**FINAL IMPLEMENTATION DOCUMENT  
OTHER CONTAMINATION SOURCES  
INTERIM RESPONSE ACTION  
SOUTH TANK FARM PLUME**

**Prepared by  
MK-Environmental Services  
Denver, Colorado**

**Prepared for  
Shell Oil Company/Holme Roberts & Owen  
Denver, Colorado**

**RESPONSES TO COMMENTS ON THE  
DRAFT IMPLEMENTATION DOCUMENT  
OTHER CONTAMINATION SOURCES  
INTERIM RESPONSE ACTION  
SOUTH TANK FARM PLUME**

Annual Monitoring  
Network

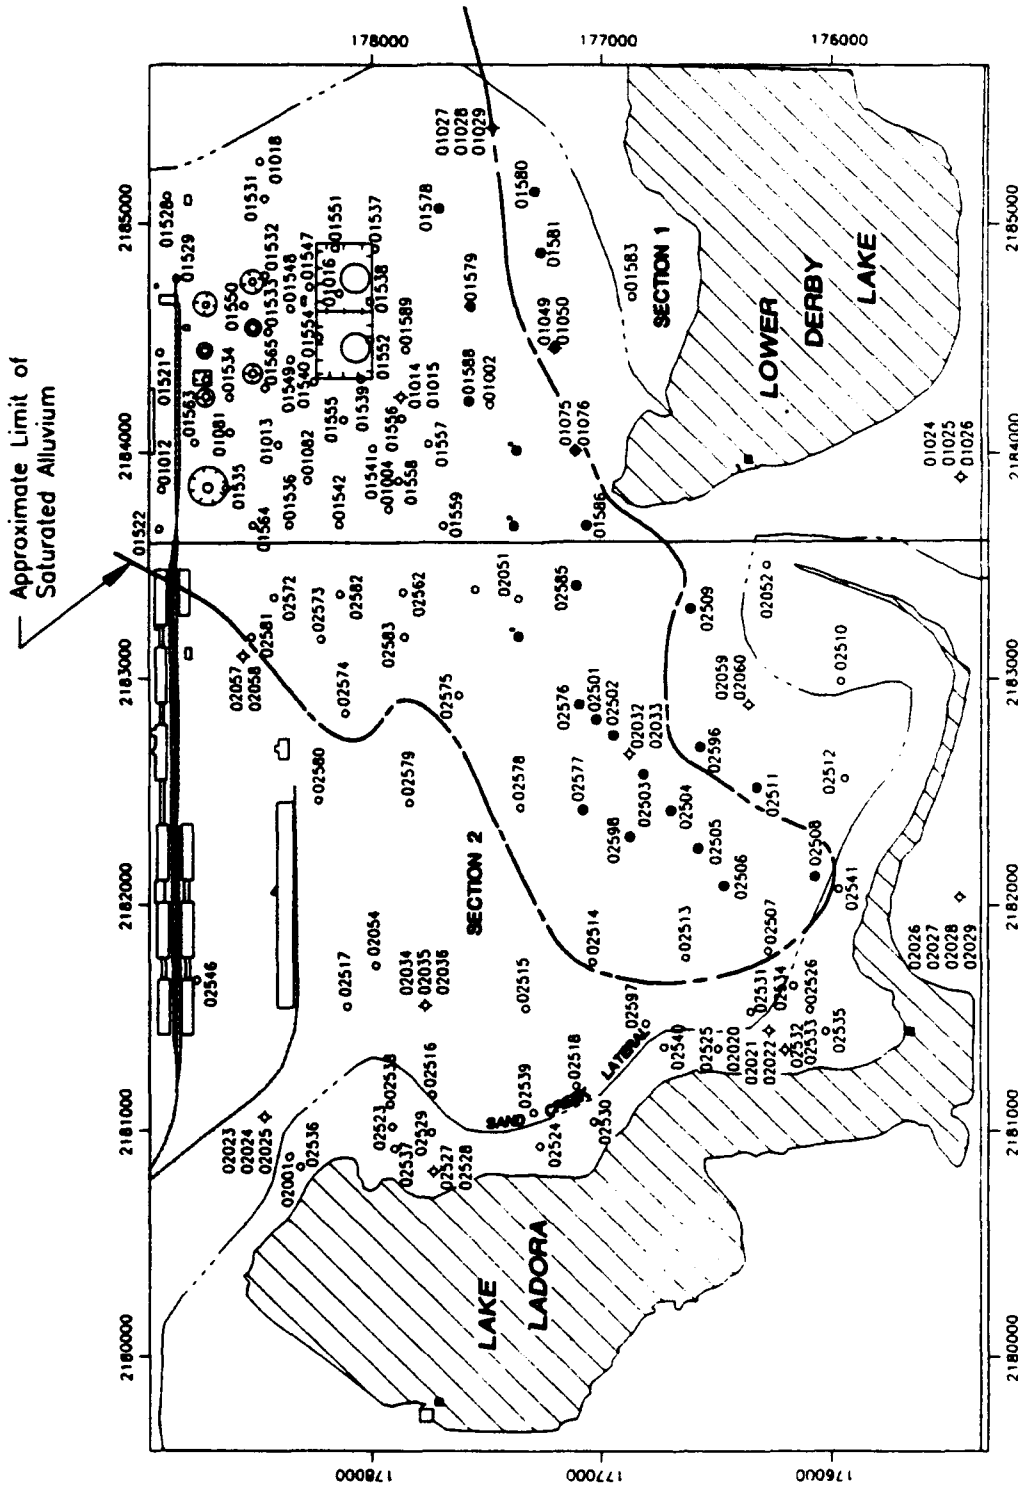
6. Figure 4. The annual monitoring network as presented by Shell in this figure excludes two wells originally included

in the sampling program in the Final Decision Document Other Contamination Sources Interim Response Action South Tank Farm Plume, May 1991 ([Final Decision Document], Figure 4-2), Wells 02577 and 02598. Well 02577 had spring 1988 and spring 1990 benzene detections of 94.2 ug/l and 37.7 ug/l, respectively, and Well 02598 had a spring 1990 benzene detection of 89.6 ug/l (these two wells both had fall 1989 and fall 1990 concentrations below detection limits, again indicating cyclicity in the data). Additionally, both wells had detections of 11DCLE, 12DCE, CHCL3, and TRCLE. Please include these wells in the annual monitoring network as originally presented in the Final Decision Document.

**Response:** Figure 4 has been corrected to show that these wells are included in the monitoring network.

**LOCATION MAP FOR NEW  
WELL PONTS AND  
PIEZOMETERS**

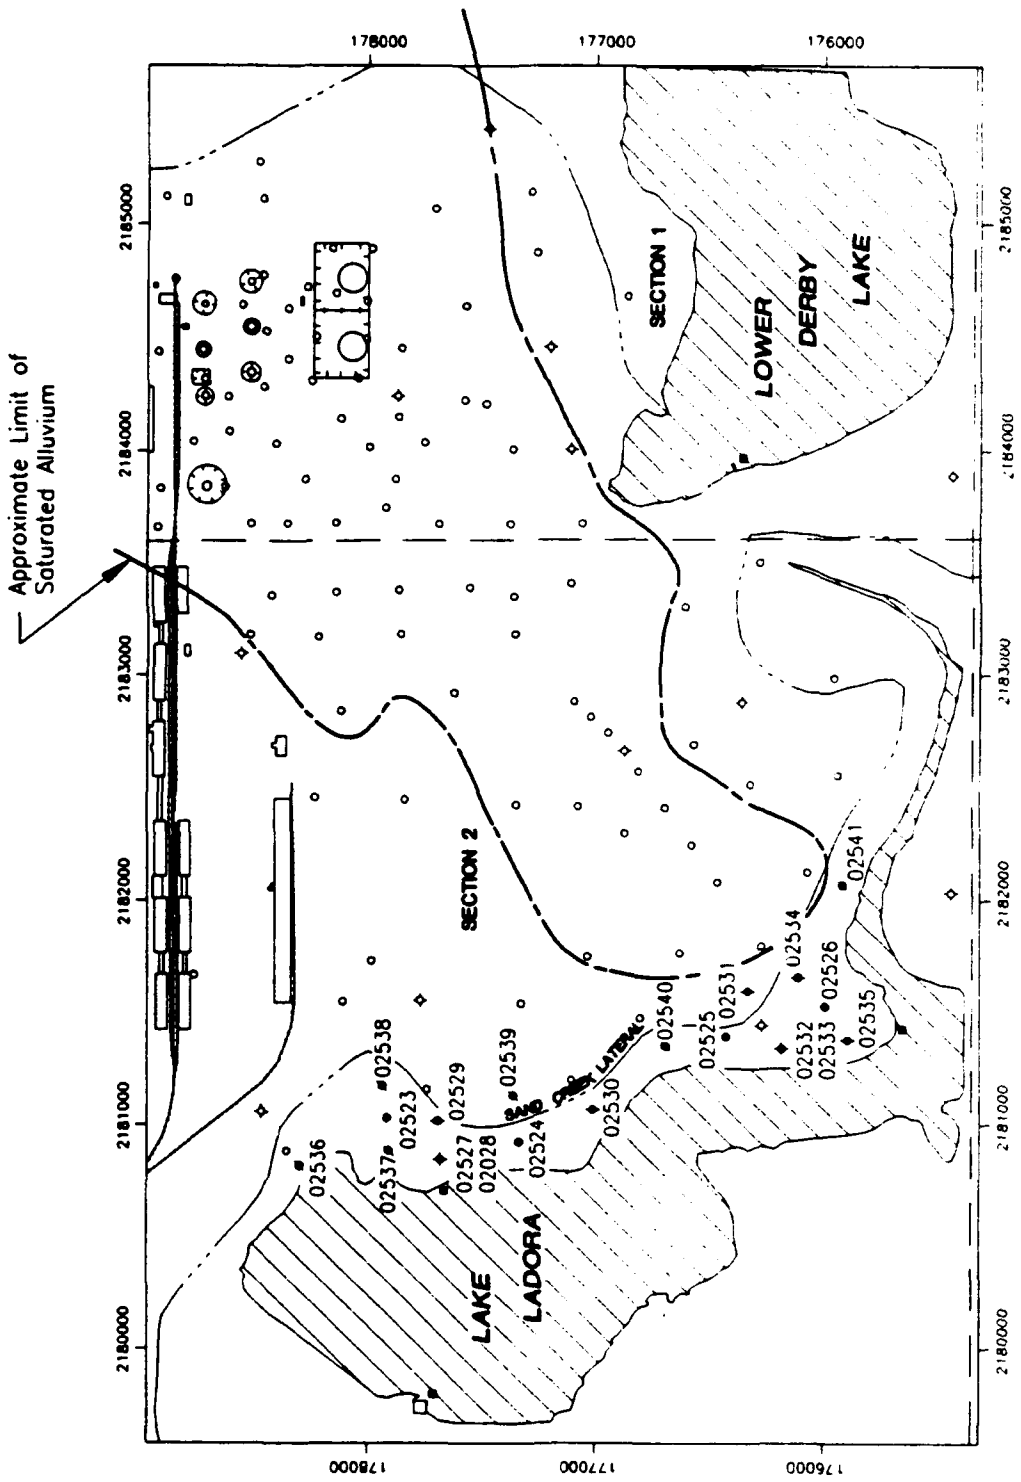
1. Page following page 3-5, Figure 6. One of the piezometer locations is reported as Well 01231. This appears to be a typographical error. This location corresponds to Well 02531 shown on Figure 5. Please confirm this well's proper identification number and correct Figure 6 accordingly.

**Response:** The well number has been corrected on the figure.

Water Table  
Contour Map  
June 1991

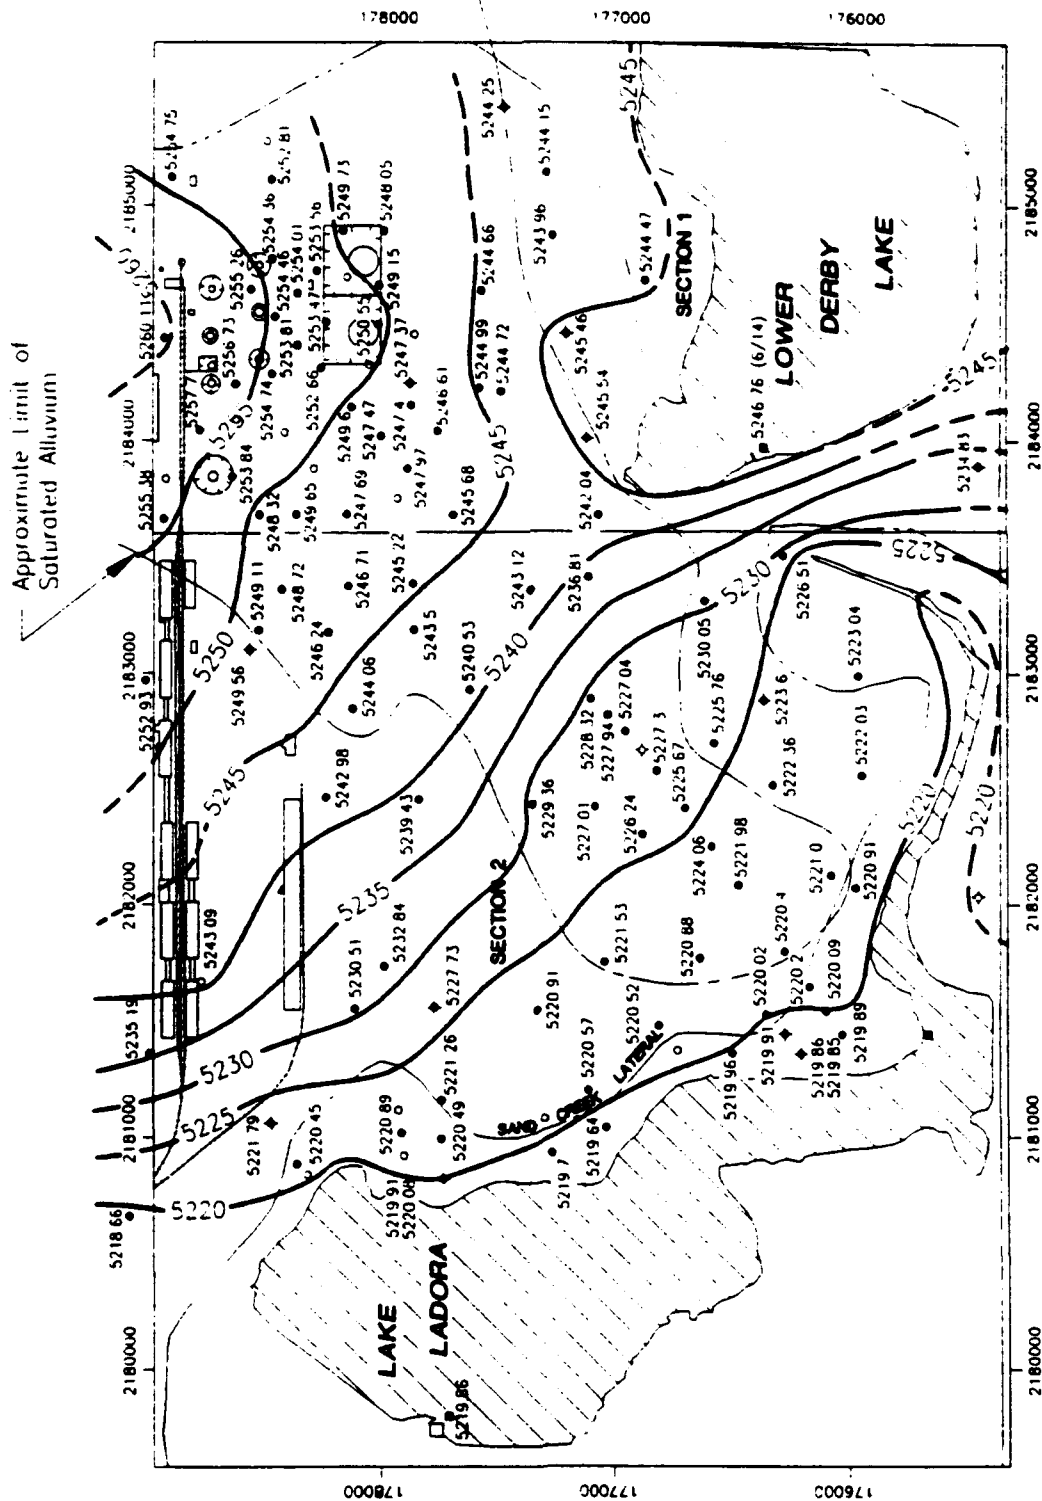
4. Appendix A, page A-2, third paragraph, second to the last sentence. Well point 02539 was reported as unplugged after using a variety of well development techniques. However, the water-table elevation measurement for this well was not given. Please provide this information on Figure A-1.

7. **Page A-2.** Shell states that two staff gages were installed along the eastern edge of Lake Ladora, however, the gage locations are not presented on Figure A-1. Please include these locations on the figure.

8. **Page A-2.** Shell presents the datum for only one of the two new staff gages. Please present the respective datum for each gage, and clearly label the gages on Figure A-1.

**Response:** A water level was not provided for Well 02539 because the well was unplugged after the water level

**Response:** The figures now include the location of the two new staff gages.

**Response:** Please refer to the response to EPA Specific Comment 3.

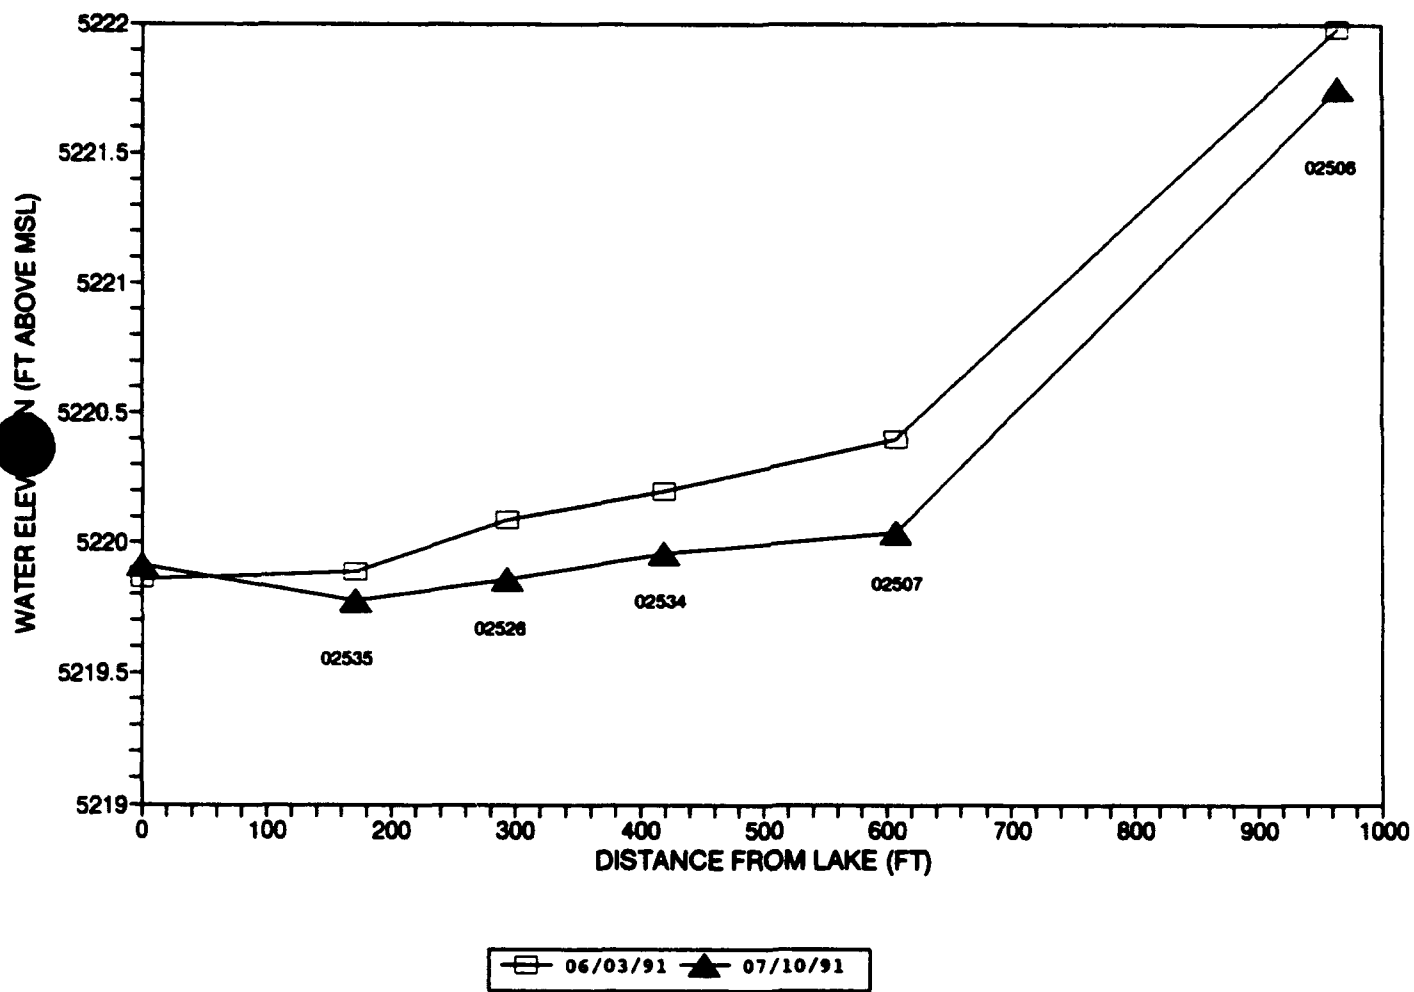
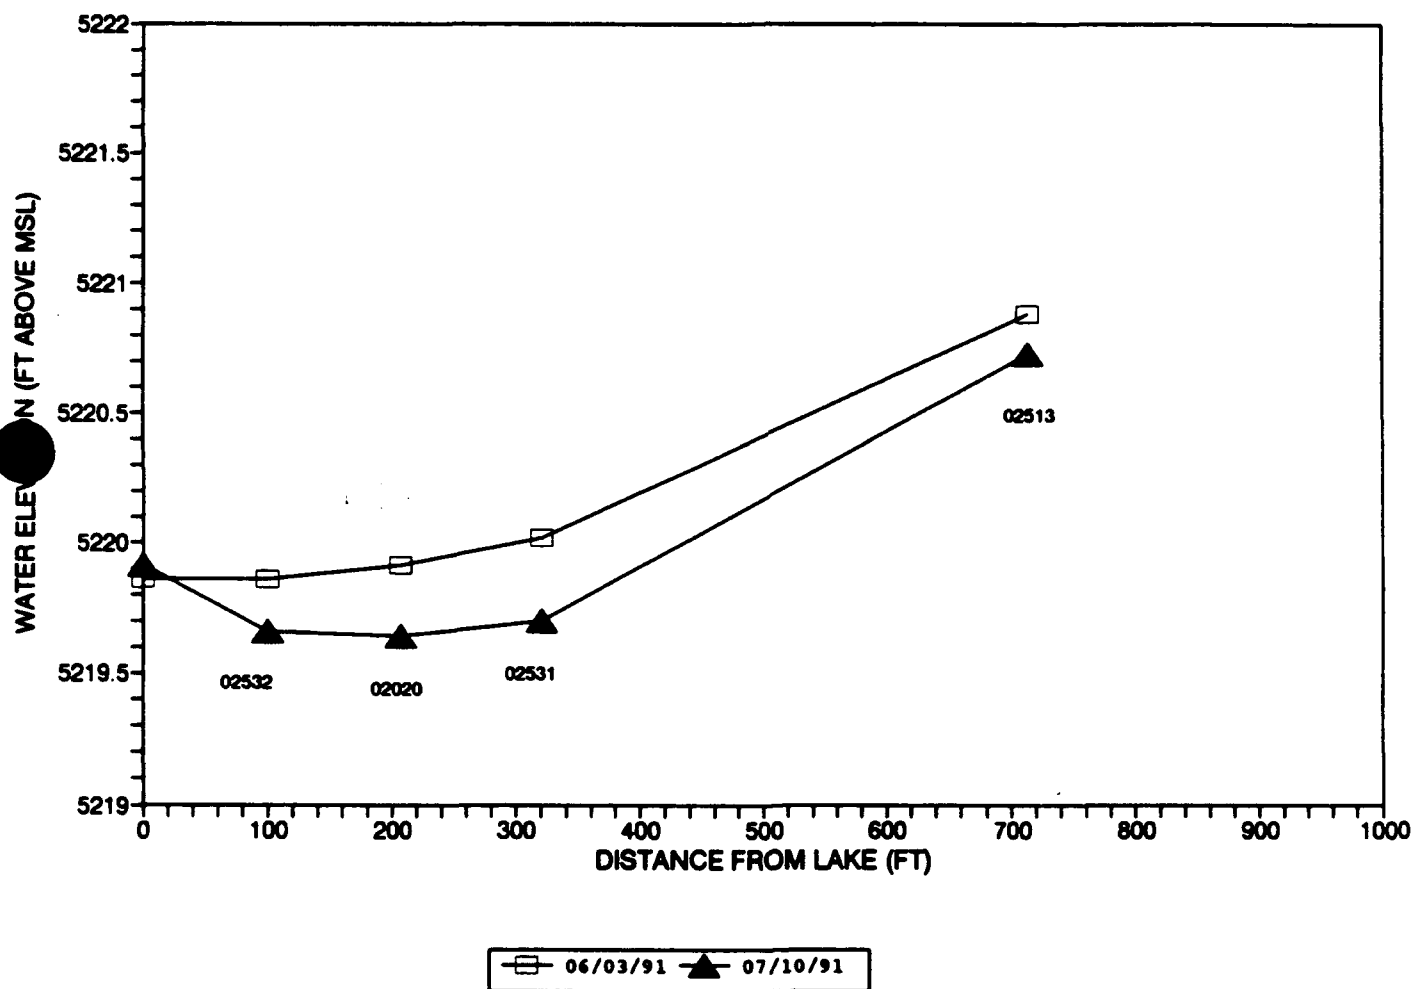
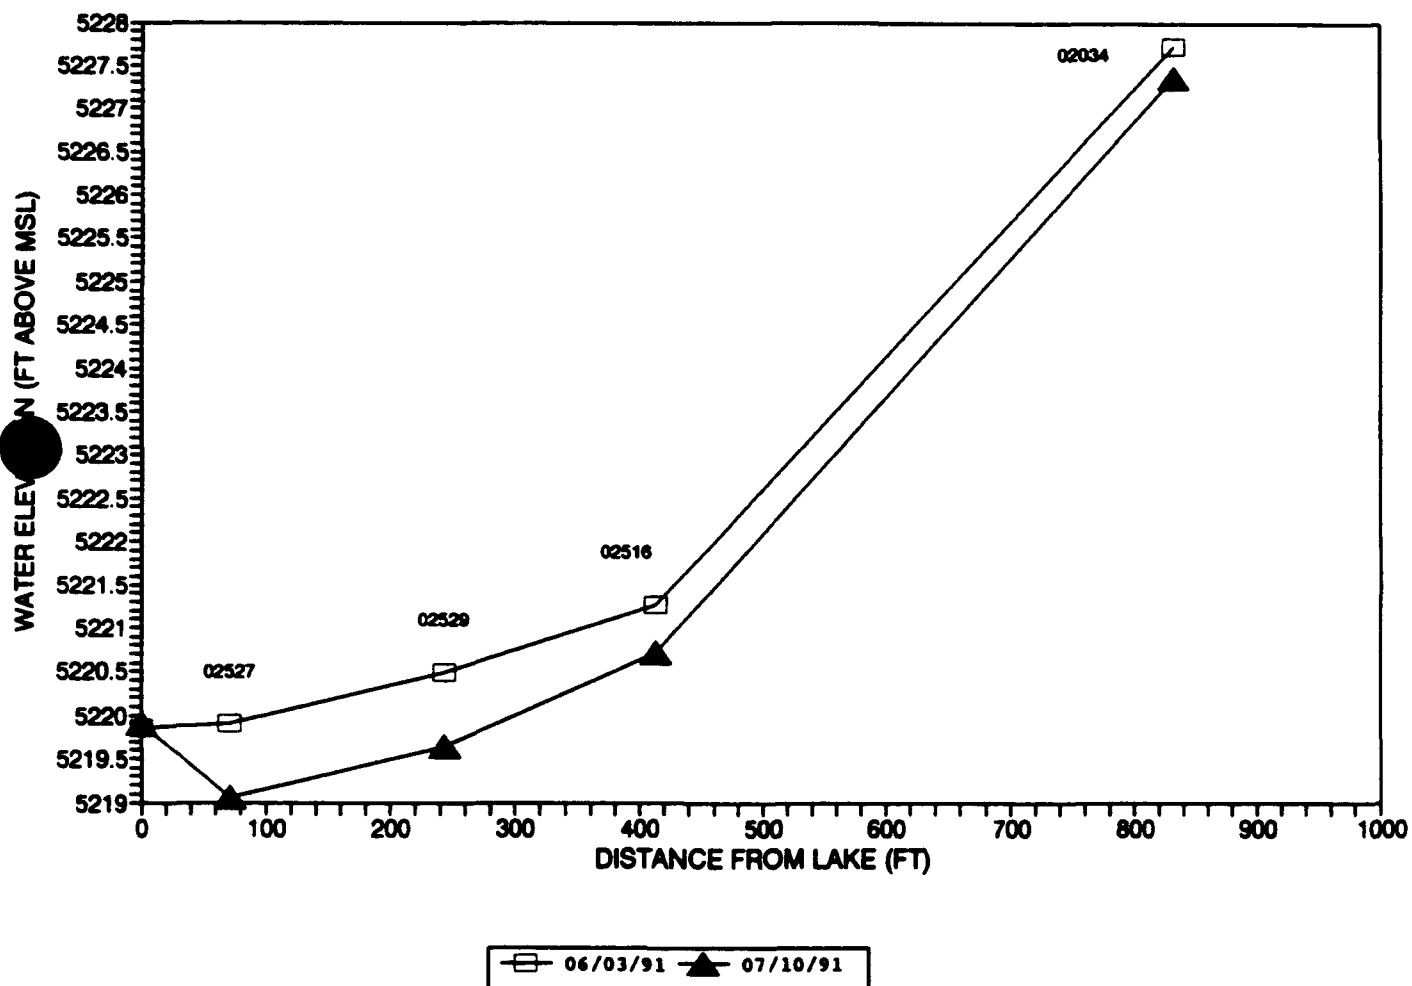
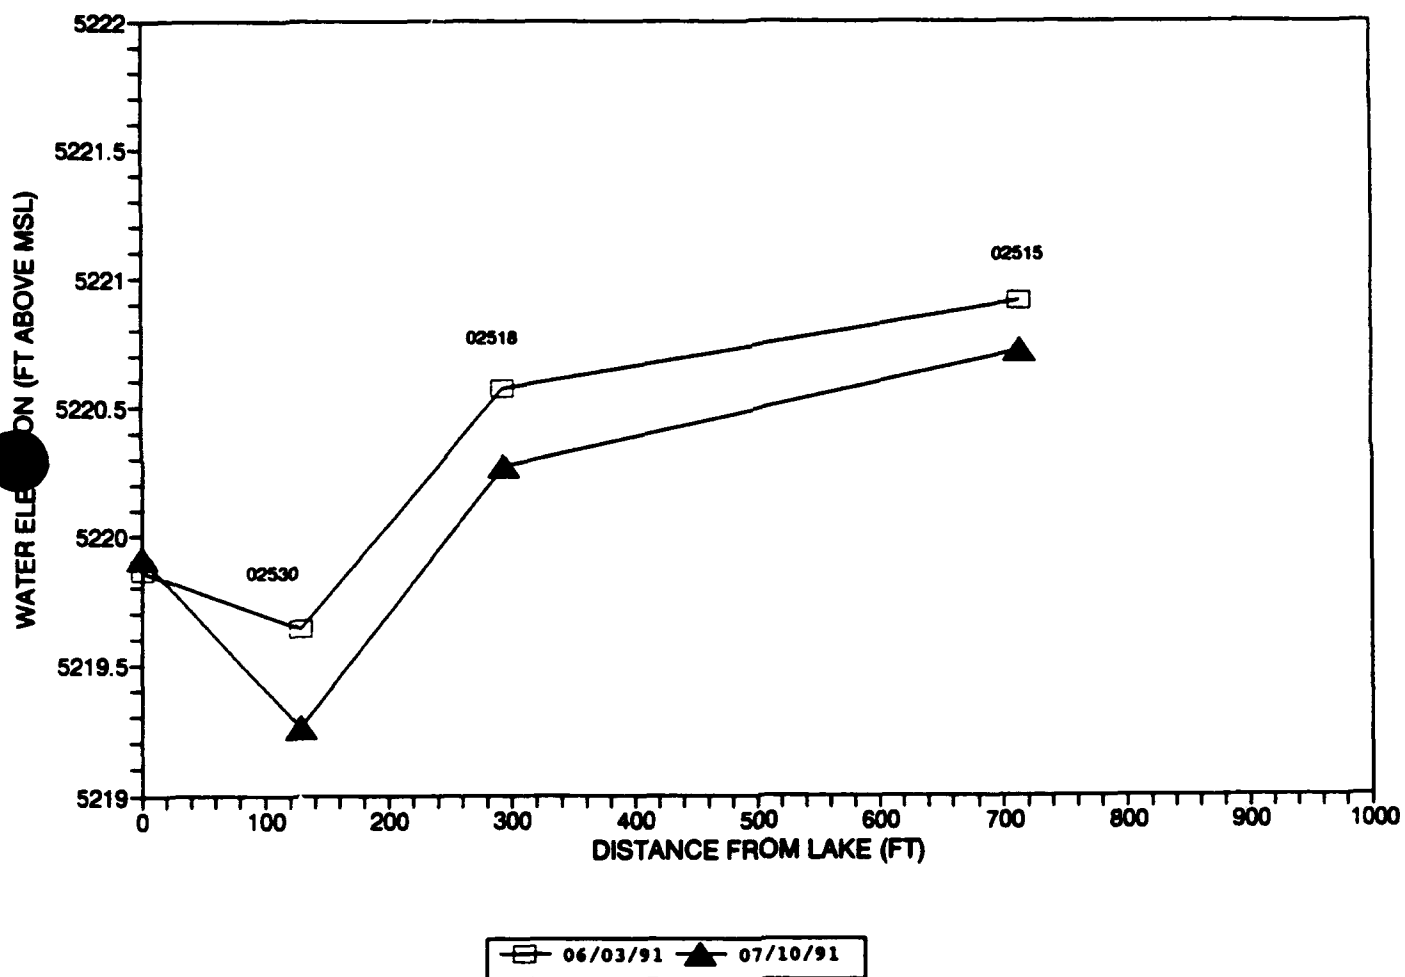
14. Figures A-2 to A-6. Please provide the numerical value for the lake water level on May 28, 1991, and for consistency, include this value on Figure A-1 (instead of the 5/23 measurement).
